Kansas Department of Agriculture
Division of Water Resources
CHANGE: PD P/U WORKSHEET

KANSAS DEPARTMENT OF AGRICULTURE
Division of Water Resources
MEMORANDUM

DATE: December 8, 2016
RE: Water Right
File Nos. 27,121; 34,520 and
35,749

**APPROVAL OF APPLICATION
FOR
CHANGE IN PLACE OF USE
AND POINT OF DIVERSION
WATER RIGHT
FILE NO. 35,749**

Application Proposed Place of Use Changes, File Nos. 27121, 34250, & 35749

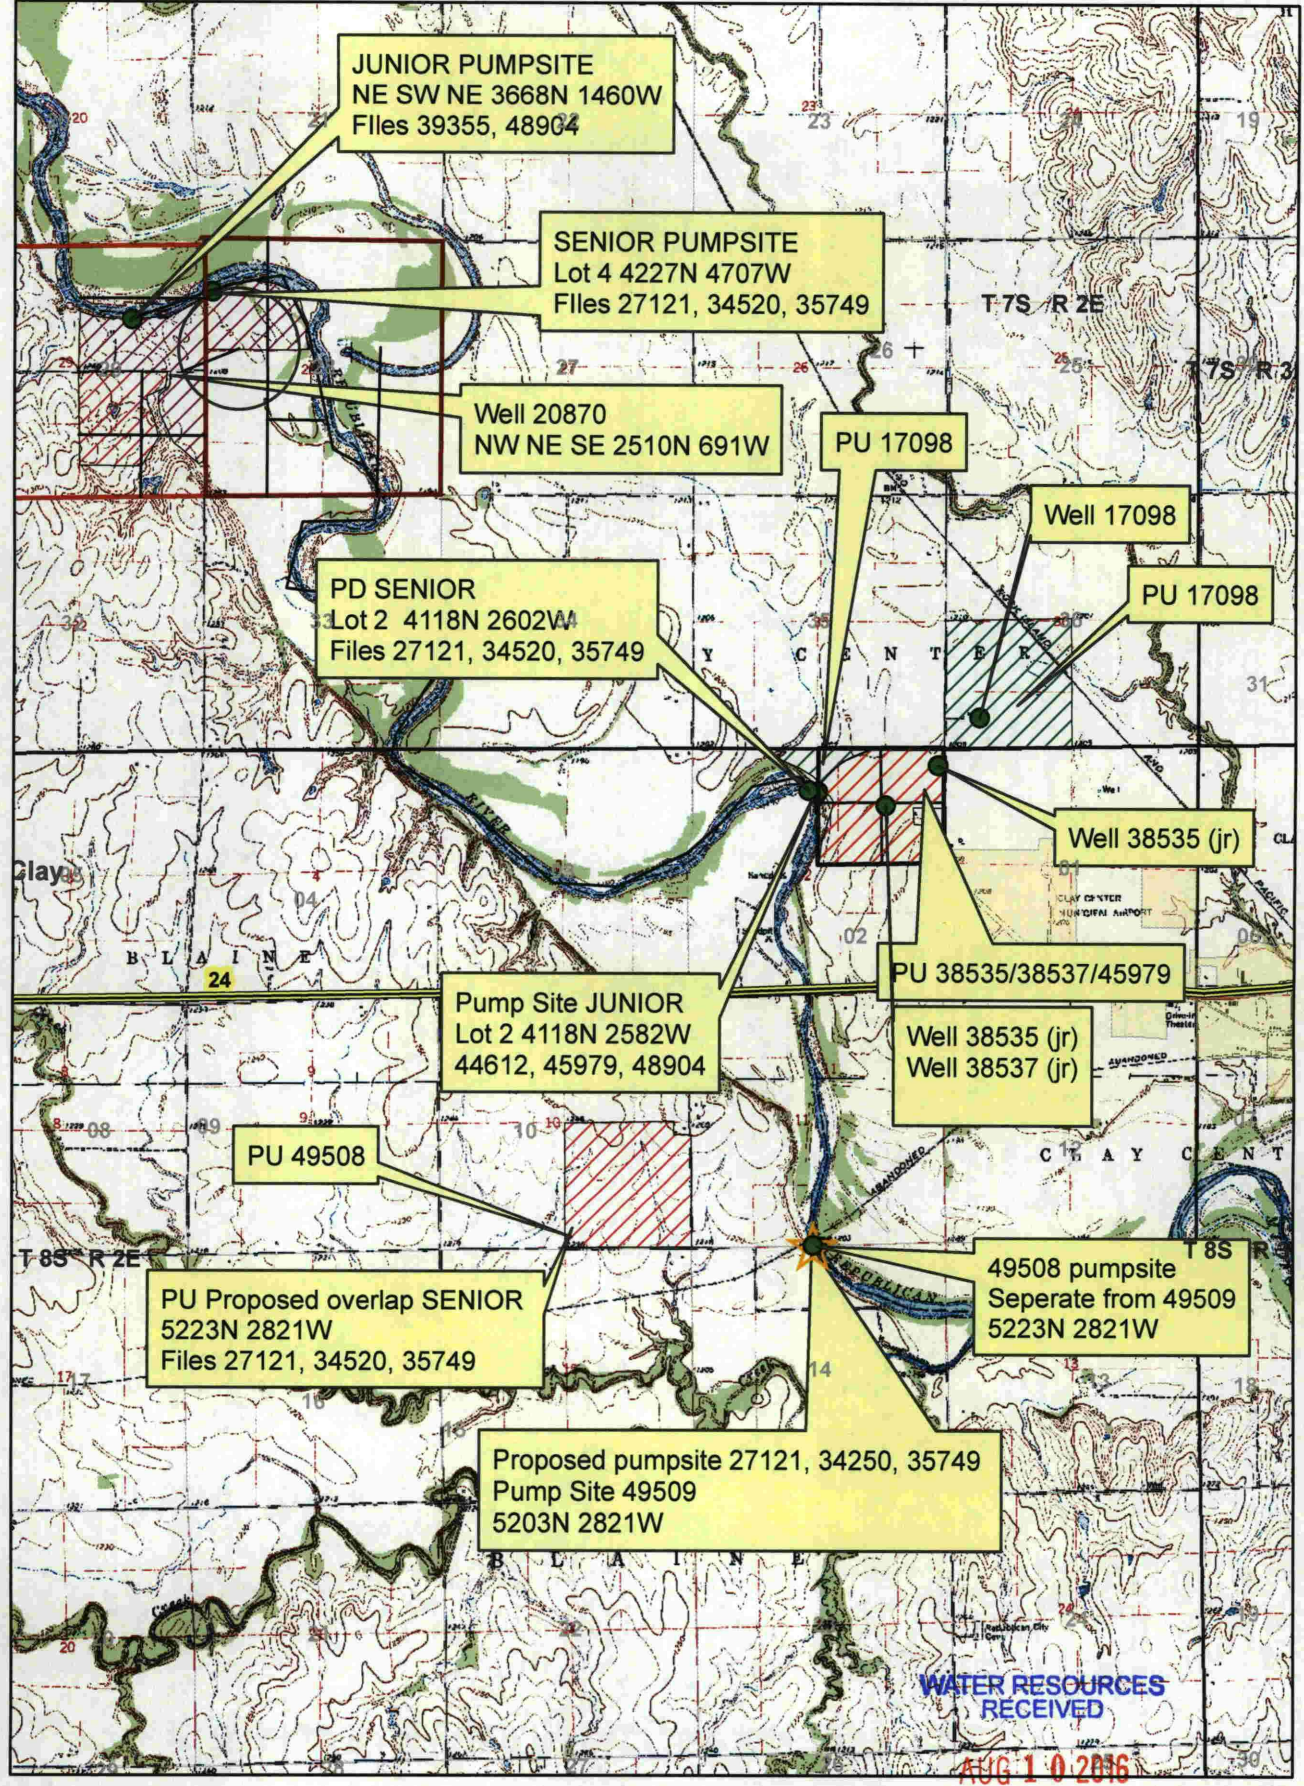
3. The change(s) proposed herein are desired for the following reasons (please be specific): To add a SR water pumpsite to new portion of the project and Create Overlap. This Change adds PD in 14-TBS-132E & adds PU in 10-TBS-R2E.

ALL land under 4a, 4b, & 5 will remain authorized.
 Add the 135 Acres in 10-8S-2E.

Proposed pumpsite 27121, 34250, 35749
Pump Site 49509
5203N 2821W

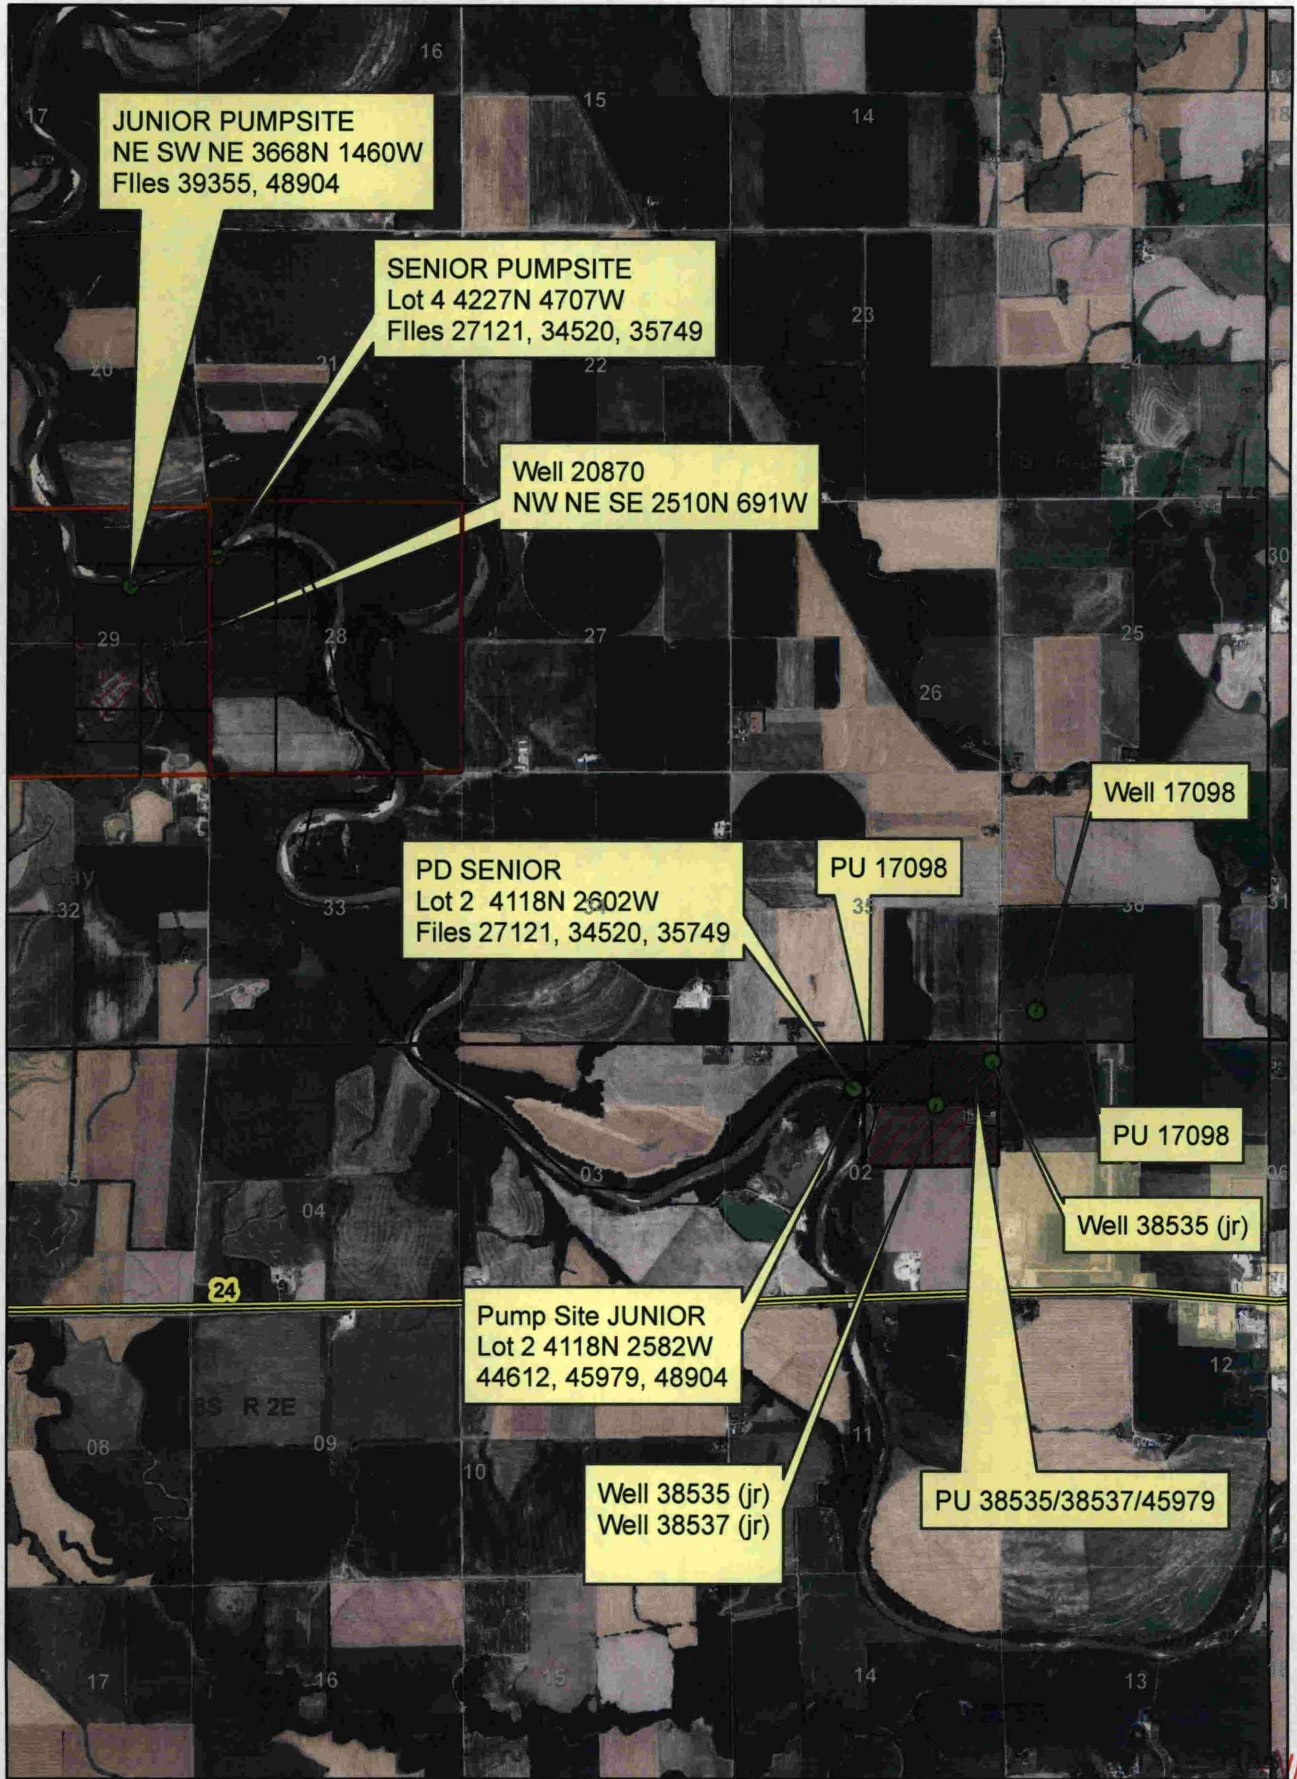
The water right owners also propose to add a pumpsite now authorized by Appropriation of Water, File No. 49,509 to File Nos. 27,121; 34,520 and 35,749. The proposed existing pumpsite, located approximately 1.89 miles downstream from the closest authorized pumpsite, will move senior priorities downstream of junior priority pumpsites not under common ownership – File Nos. 44,867/45,544; 46,836/47,823/49,154 and 47,748. Paragraph No. 3 indicates the purpose of the change is to allow a senior priority pumpsite to irrigate the place of use currently authorized by File No. 49,508.

10. ~~Presently authorized~~ **point of diversion: TO BE ADDED**
 One in the NE Quarter of the NE Quarter of the NW Quarter of the _____ Quarter of the _____
 of Section 14, Township 8 South, Range 2 (EW),
 in Clay County, Kansas, 5203 feet North 2821 feet West of Southeast corner of section.
 Authorized Rate _____ Authorized Quantity _____
 (DWR use only: Computer ID No. _____ GPS _____ feet North _____ feet West)
 This point will not be changed This point will be changed as follows:
Proposed point of diversion: (Complete only if change is requested)
 One in the _____ Quarter of the _____ Quarter of the _____ Quarter of the _____
 of Section _____, Township _____ South, Range _____ (EW),
 in _____ County, Kansas, _____ feet North _____ feet West of Southeast corner of section.
 Proposed Rate _____ Proposed Quantity _____
 This point is: Additional Well Geo Center List other water rights that will use this point _____
